**Submittal No.:** 04c2: Containment Plans, Rev 3b

**Description:** Proposal/Contract Number: Bennington-Mt. Tabor BF BPNT (16)

Project Description: Bridge Painting of Five Bridges

### ABRASIVE BLASTING CONTAINMENT PLANS, REV. 3

**TYPICAL SECTION - BRIDGE NO. 165**  
(PHASES I THRU III)  
(MOBILE DUST COLLECTOR NOT SHOWN FOR CLARITY)

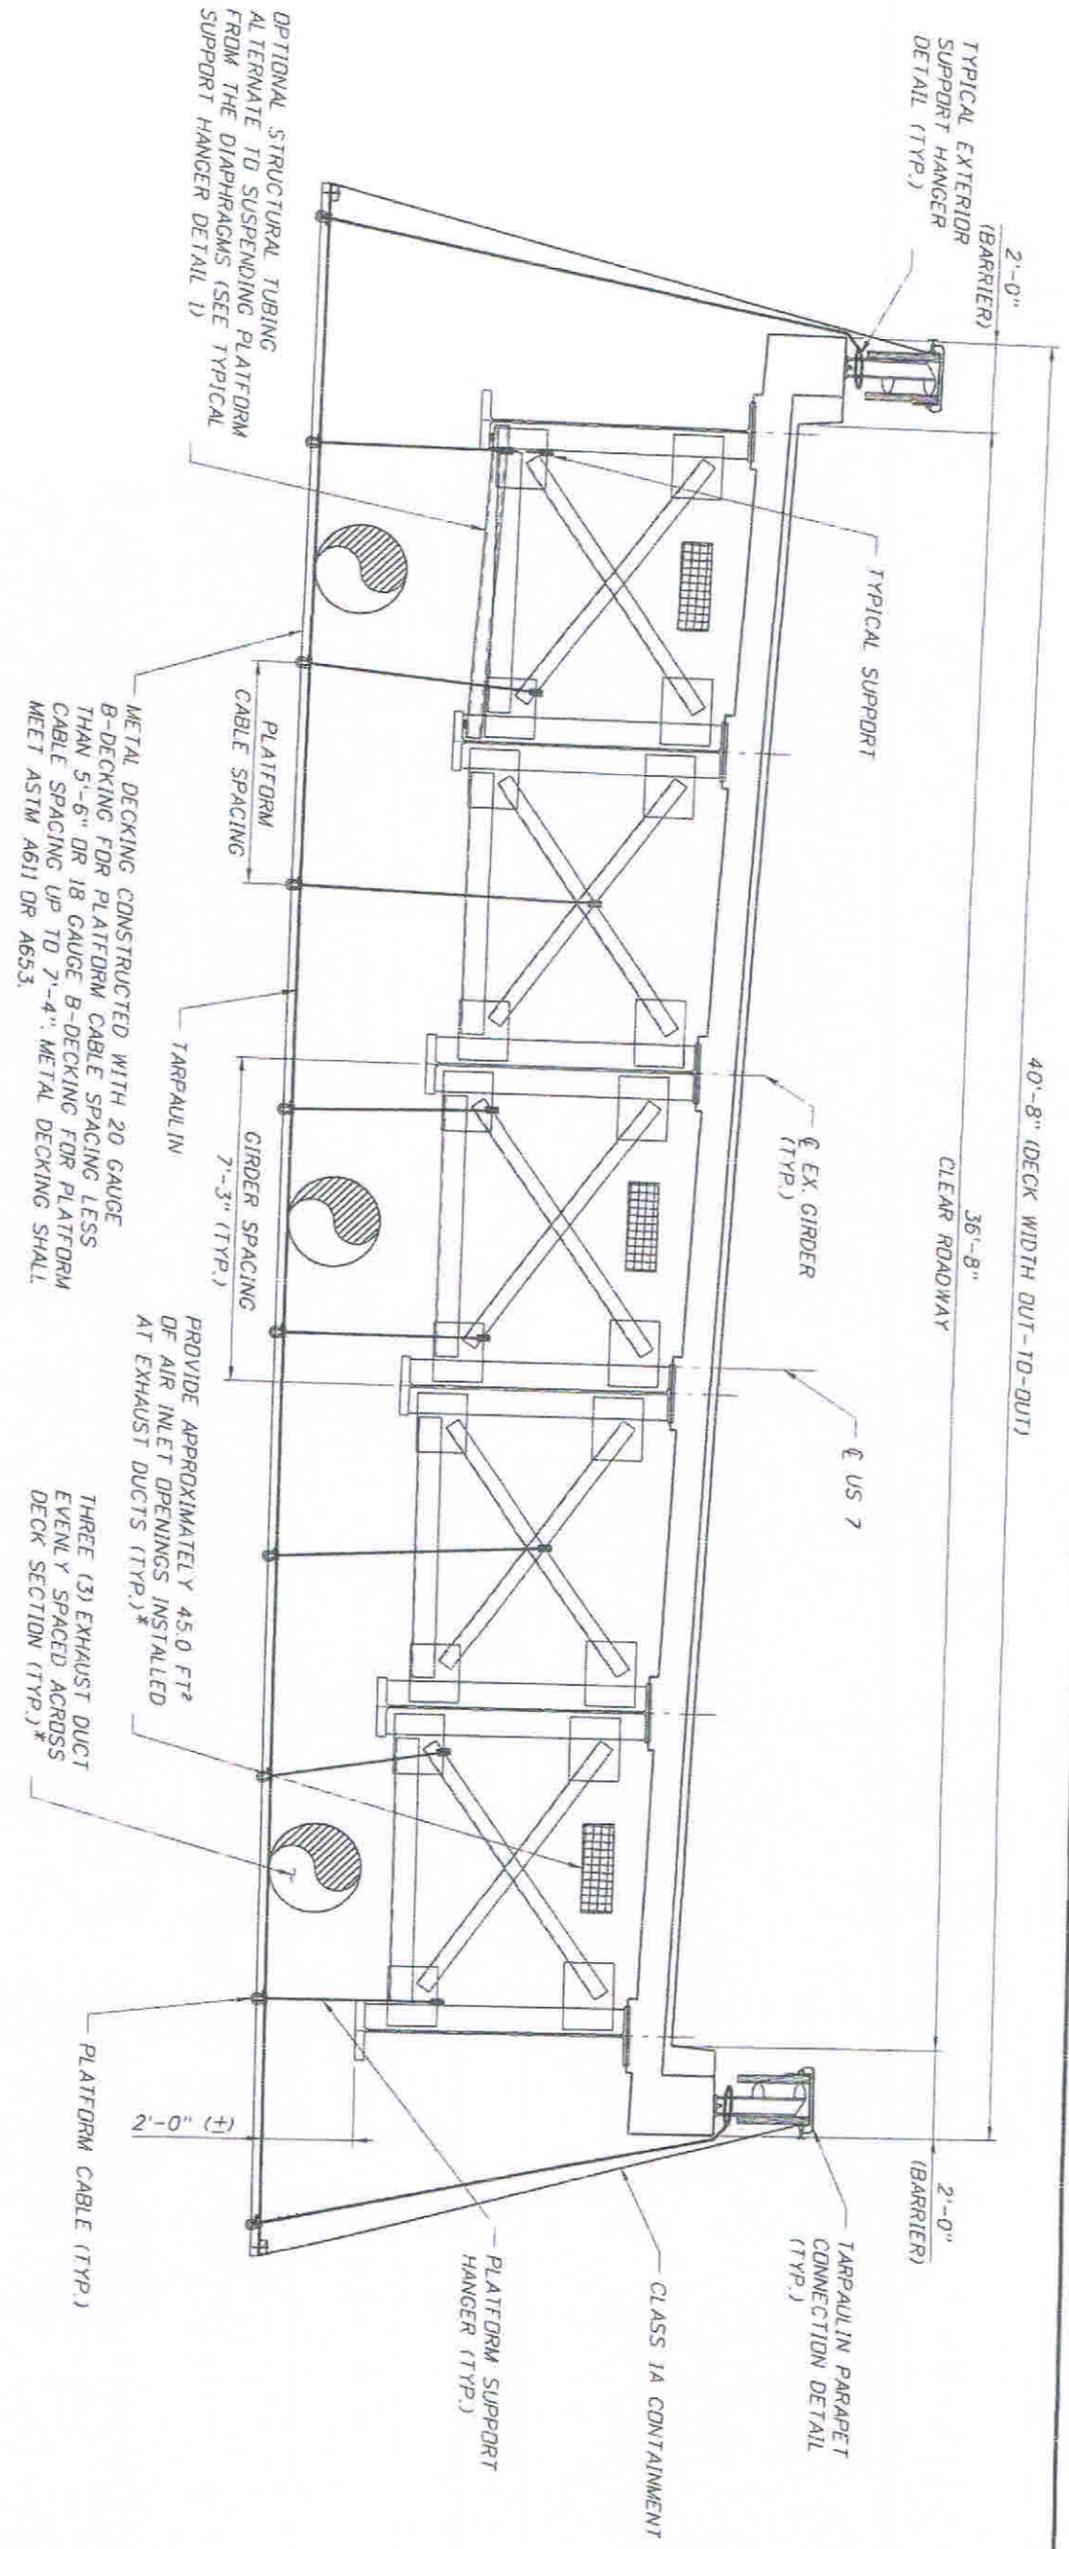
**We have added and additional sheet (C-11A) to show Bridge No. 16N. Minor changes were only made to sheets C-10, C-11, C-11A and C-11B. Let us know if you have any questions**
